**CITY COUNCIL APPEAL HEARING
AUGUST 31, 2026, 5:00 P.M.
LIBRARY COMMUNITY ROOM
702 E. FRONT AVENUE**

1. **Action Item** (Quasi-judicial) APPEAL OF ITEM S-2-26: Coeur Terre 2 Subdivision

**CITY COUNCIL
STAFF REPORT**

SUBJECT: S-2-26AA: ADMINISTRATIVE APPEAL OF THE PLANNING AND ZONING COMMISSION'S APPROVAL OF A PHASED PRELIMINARY PLAT REQUEST TO SUBDIVIDE APPROXIMATELY 202.01 GROSS ACRES OF EXISTING PROPERTIES INTO 284 SINGLE-FAMILY AND 36 MULTI-FAMILY LOTS, A PUBLIC PARK, A PUBLIC-SCHOOL SITE, AND ASSOCIATED NON-BUILDABLE TRACTS, KNOWN AS THE COEUR TERRE 2 SUBDIVISION.

Coeur Terre 2 Road Connection Phasing Diagram: Appaloosa Rd. Faces Certain Failure

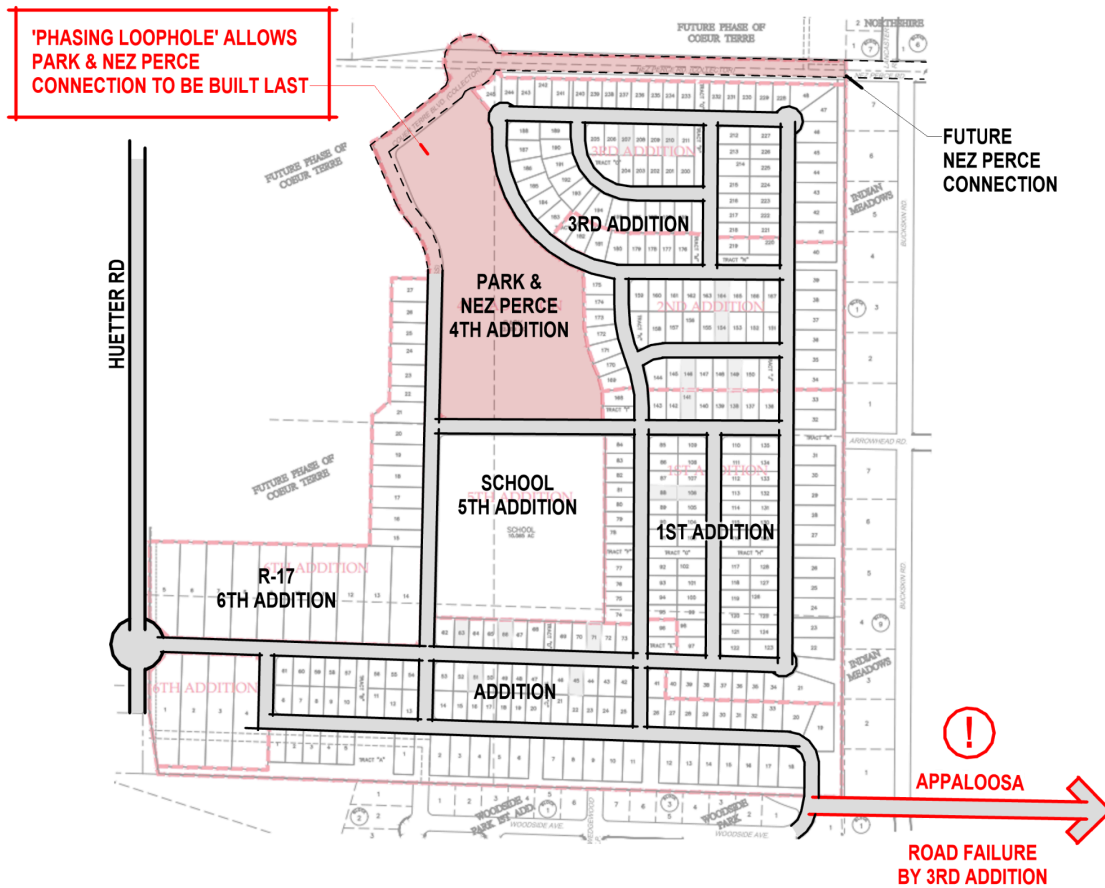
This 42-trip margin of error is completely erased when accounting for State-mandated Accessory Dwelling Units (ADUs), regional growth, and cut-through trips. State law (SB-1354) deregulated ADUs state-wide; however, the Traffic Impact Analysis (TIA) improperly assumed there would be zero by-right ADUs built within Coeur Terre 2. Generating traffic for even a small percentage of by-right ADUs across the 293 homes built by the 3rd Addition guarantees Appaloosa Road will exceed its 100% physical capacity, resulting in failure of the existing residential infrastructure.

This interim failure at the 3rd Addition is exactly why the 199-acre phasing loophole is so dangerous. If Appaloosa Road fails at 293 homes, allowing the developer to utilize 'conceptual phasing' to build all 506 homes without opening Nez Perce Road transforms a potential risk into a long term failure of the existing neighborhood road system.

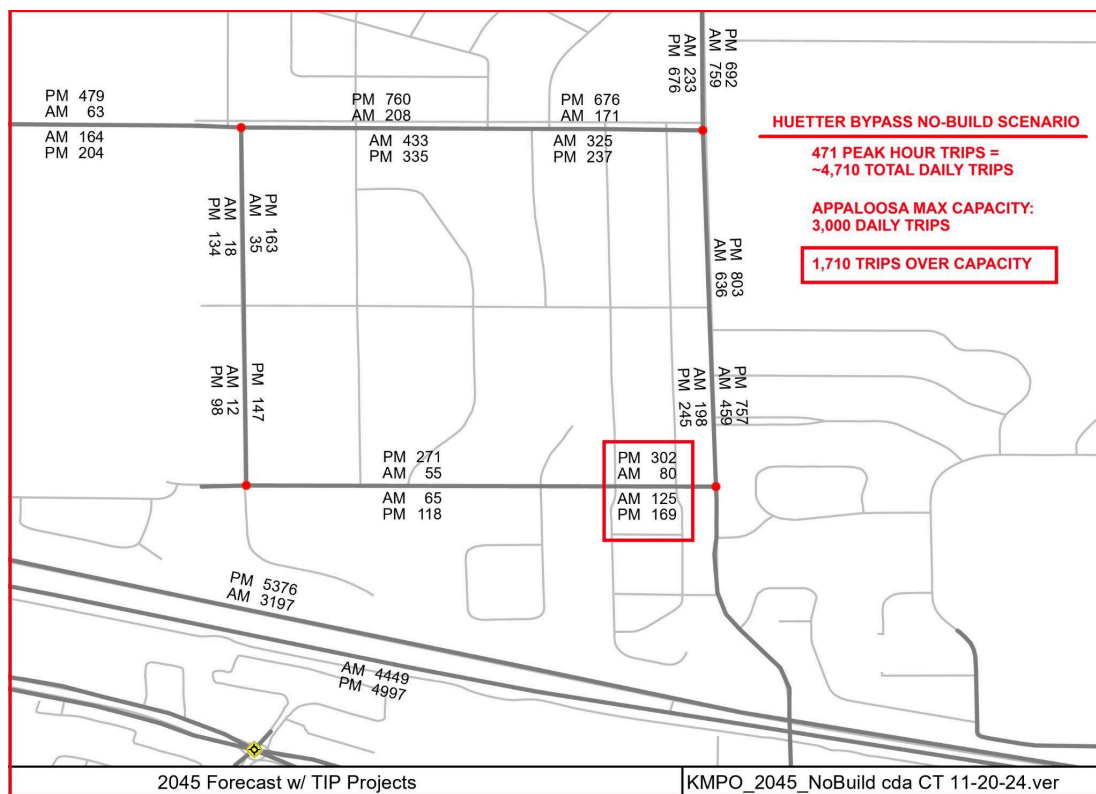
Based on CivTech's 7/14/26 'Transportation' side, Appaloosa would be completely overwhelmed as the only eastern connection:

- **Appaloosa Capacity:** 3,000 ADT (per CivTech 7/14/26 presentation)
- **Existing Traffic:** 1,598 ADT (CDA Webmap Traffic Counts, dated 7/14/26-7/16/26)
- **Total Coeur Terre 2 Eastbound Trips:** 4,200 ADT (per CivTech 7/14/26 presentation)
- **Total Appaloosa Trips:** 5,798 ADT
- **Over Capacity by 2,798 Trips or 93%**

The Development Agreement mandates that Nez Perce Road be connected, but it failed to establish a specific timeline or trigger for when that must happen. The developer has exploited this omission by tying Nez Perce to a Community Park that they are not contractually required to build during this phase, and placing both into a 'conceptual' Addition 4 that can be delayed under DA Section 6.1. **As a result, the council must adopt a condition of approval decoupling the Nez Perce connection from the 12.3 acre park and explicitly tie its completion to the issuance of the 225th building permit in order to prevent the immediate failure of Appaloosa.**

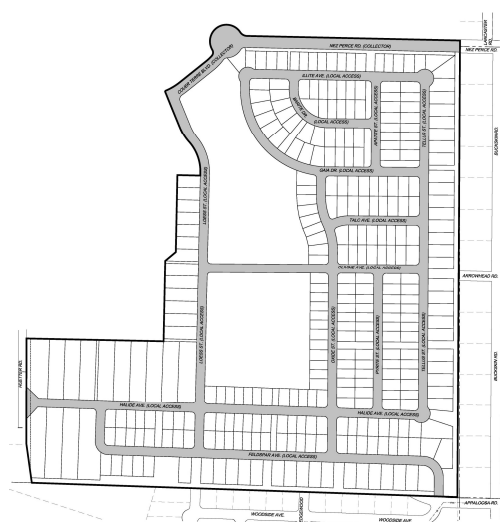
• Per the development agreement, connections to Arrowhead and Woodside were removed.

• The Masterplan has long N/S roads, allowing for unrestricted traffic movement.

• To help direct traffic away from the Appaloosa connection, we removed portions of two southbound roads, and added a westbound road to encourage traffic flow to Huetter.

TIA Concerns

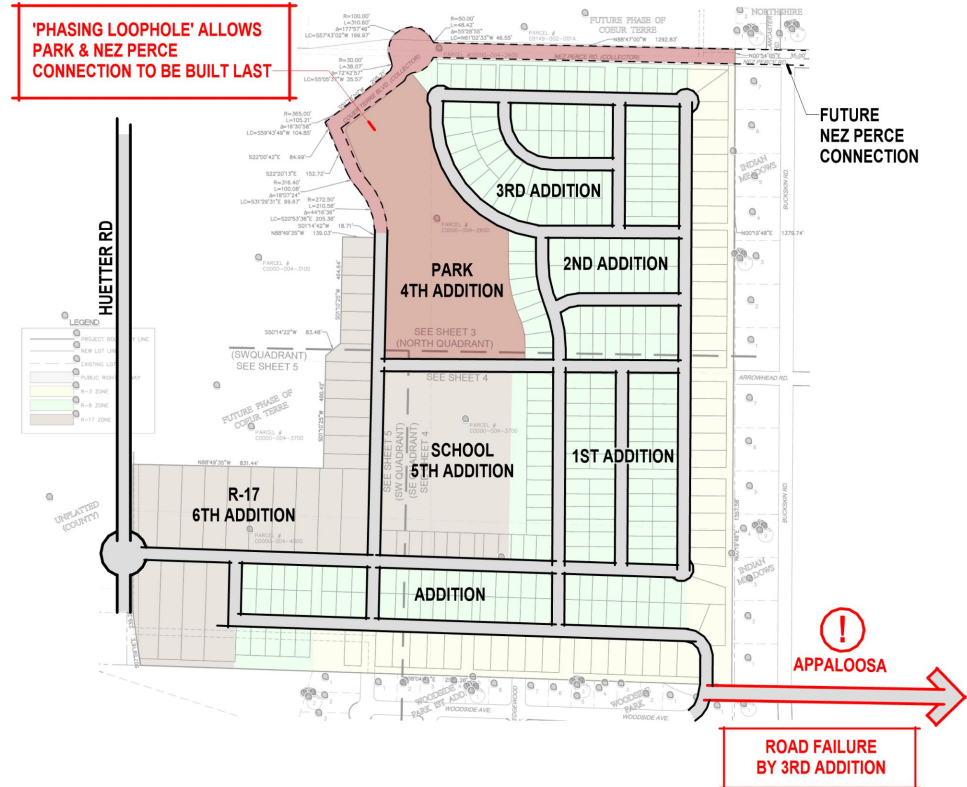
The TIA ignores ADU traffic loads, interim capacity issues (3rd Addition), and KMPD 2045 projections of long-term failure of Appaloosa Rd.

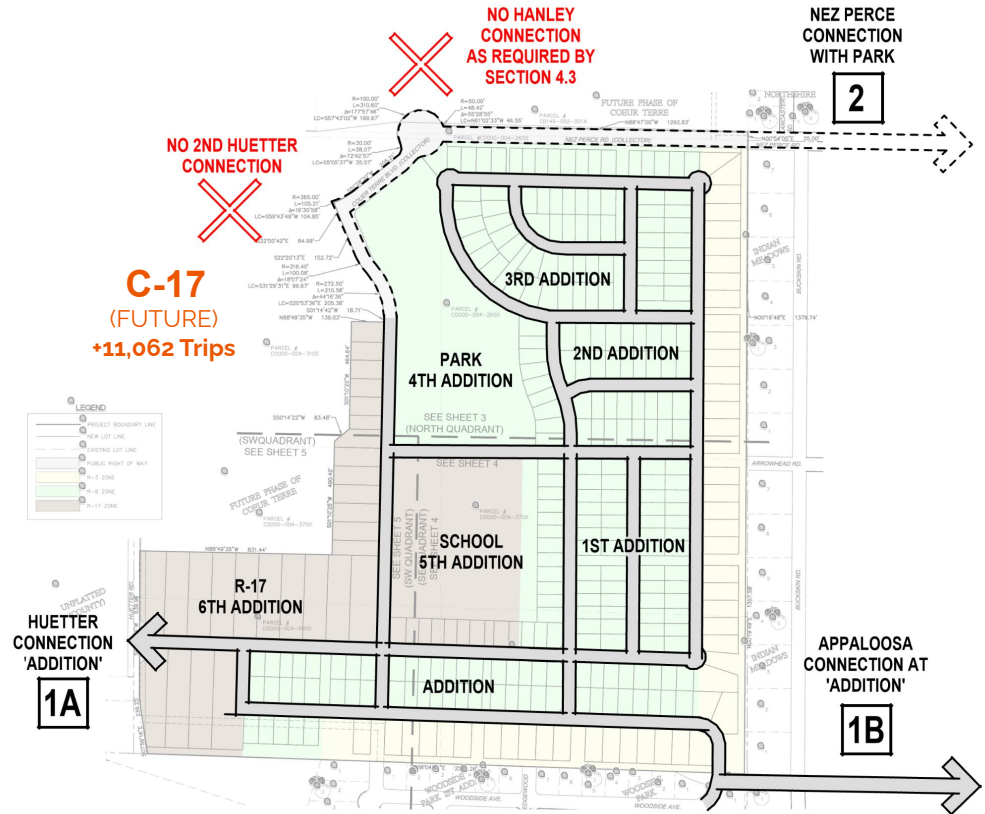
TIA projects **50% of traffic goes** through Indian Meadows. **No connection to Hanley is provided.**

The Staff claims that no direct connections to the future C-17 zone design "limits through-traffic," yet the zone is specifically excluded from Coeur Terre 2. Therefore, it cannot be used as justification.
"CT2 Staff Report, "Additional Details", Streets commentary

Diagram based on fig. 2, Coeur Terre 2 Preliminary Plat

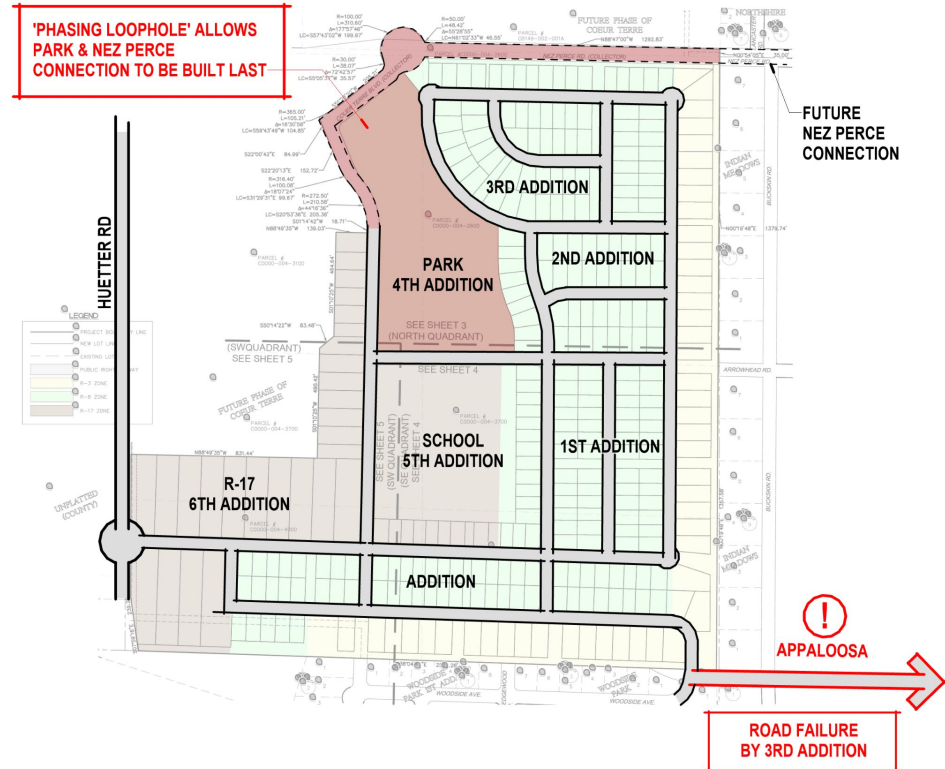
The "Capacity Cliff":

Immediate Traffic Surges +
Delayed Infrastructure =
Neighborhood Road Failure.

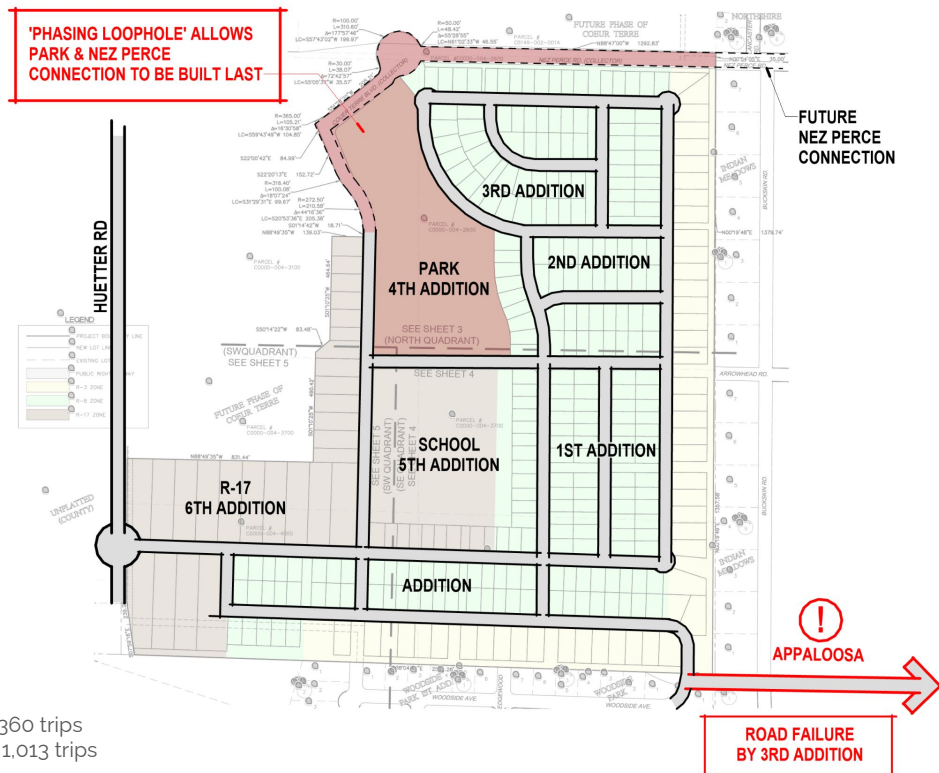
Phasing is "conceptual" and reorderable. The 199-acre trigger for the park & Nez Perce Road (4th Addition) is not reached in Coeur Terre 2 (CT1 & 2 = 190.5 acres).

RESULT: The applicant can skip the 4th Addition, build all 506 homes, and dump 100% of all eastbound traffic onto Appaloosa (~5,800 trips)!

*293 Units @ 9.28 Trips (ITE210) = 2,720 trips. 2,720 x 0.5 (50% Appaloosa) = 1,360 trips

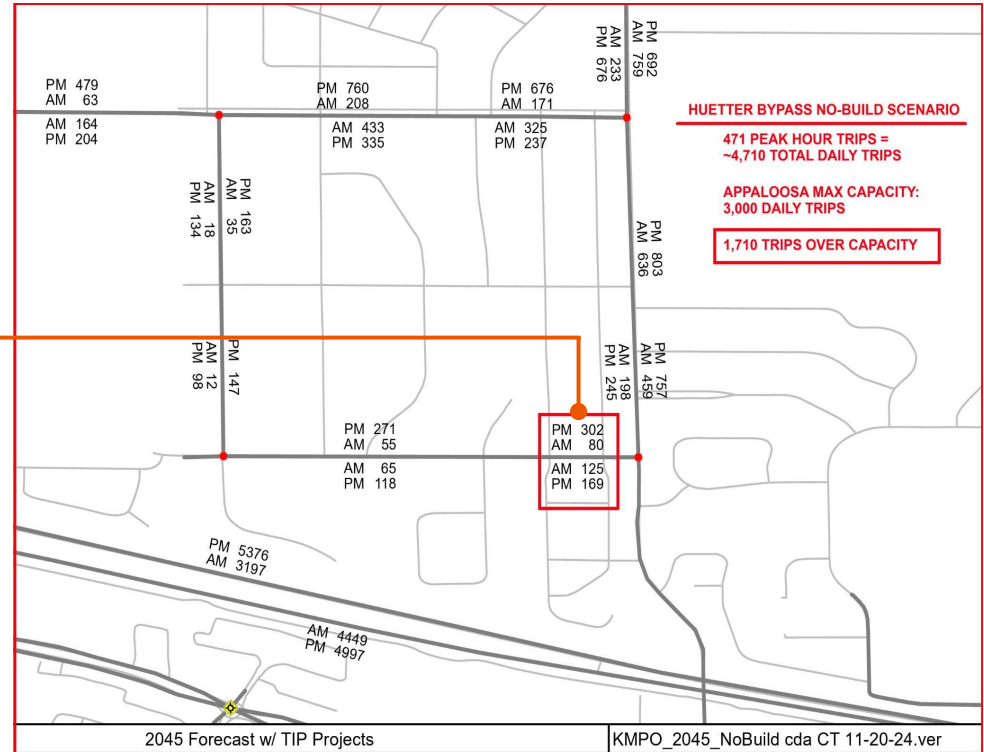
The finding disregards 2045 Kootenai Metropolitan Planning Organization (KMPO) 2045 regional traffic modeling.

KMPO modeling (11/20/24) projects Appaloosa Road will receive up to **4,700 daily trips** in 2045. **Appaloosa will be 57% over capacity.**

A Better Path Forward

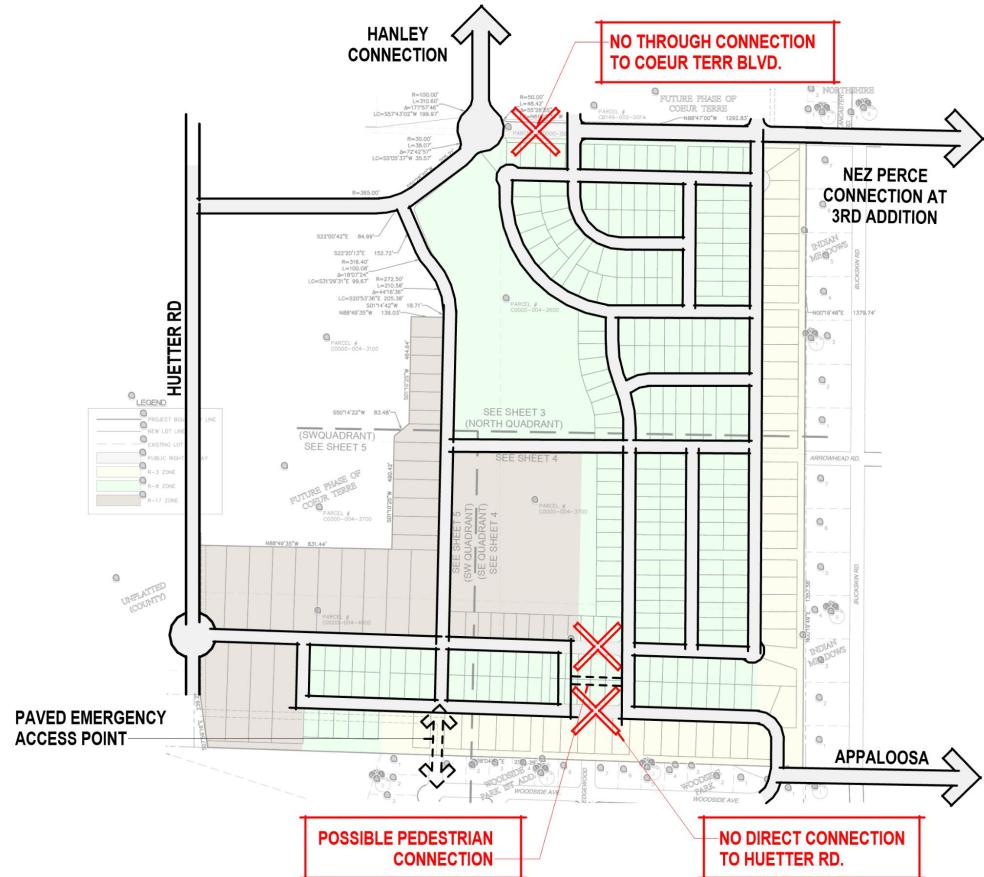
Simple internal street realignments can satisfy the DA § 4.3 mandate to discourage eastern through-traffic.
